Our Case Number: ABP-316272-23

Re: Bus Connects Templeogue/Rathfarnham to City Centre Core Bus Corridor Scheme
Templeogue/Rathfarnham to City Centre

**TEMPLEOGUE/RATHFARNHAM TO CITY CENTRE - CORE BUS CORRIDOR SCHEME
REVIEW ON BEHALF OF #55, #59, #61, #63, #65, #67 & #71 RATHFARNHAM ROAD:
AN BÓRD PLEANÁLA REFERENCE ABP-316272-23**

TEMPLEOGUE/RATHFARNHAM TO CITY CENTRE - CORE BUS CORRIDOR SCHEME
REVIEW ON BEHALF OF #55, #59, #61, #63, #65, #67 & #71 RATHFARNHAM ROAD:
BASED ON AVAILABLE DESIGN DETAILS AND TOPOGRAPHICAL SURVEY

Figure 1 – Details assumed for the Purposes of this Study

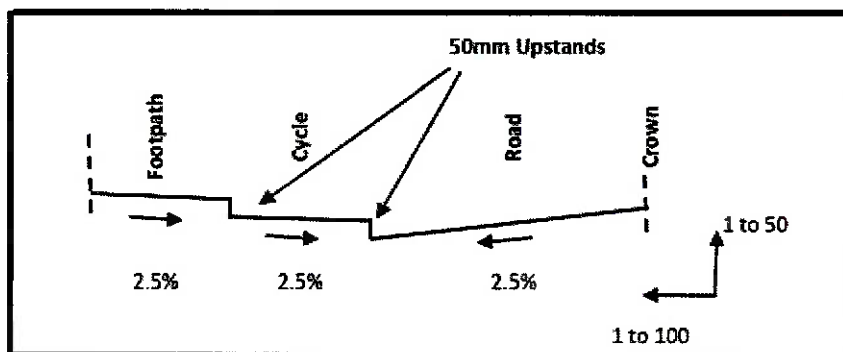
In terms of the impact upon individual residences along the route, given the scant information provided within the statutory documents and the planning application we have had to assume some typical design details (gradients and details which would normally apply to schemes of this nature, with the assumed gradients as illustrated below as **Figure 1**).

Figure 2 – Profile for #55 Rathfarnham Road

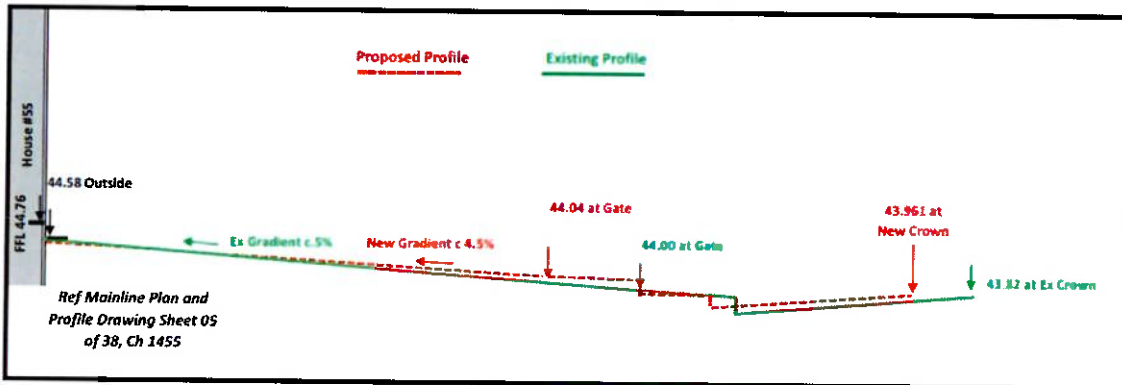
We include below a 'Before' and 'After' Cross Sectional Profile for each Property.

House Details	Current Total Gradient ¹	Future Total Gradient ²	Comment
55 Rathfarnham Rd	5%	4.5%	Improvement
59 Rathfarnham Rd	7.6%	9.6%	Significantly Steeper
61 Rathfarnham Rd	7.6%	8.9%	Significantly Steeper
63 Rathfarnham Rd	6.3%	10.5%	Significantly Steeper
65 Rathfarnham Rd	9.6%	11.1%	Significantly Steeper
67 Rathfarnham Rd	10.6%	13.6%	Significantly Steeper
71 Rathfarnham Rd	8.2%	9.3%	Steeper
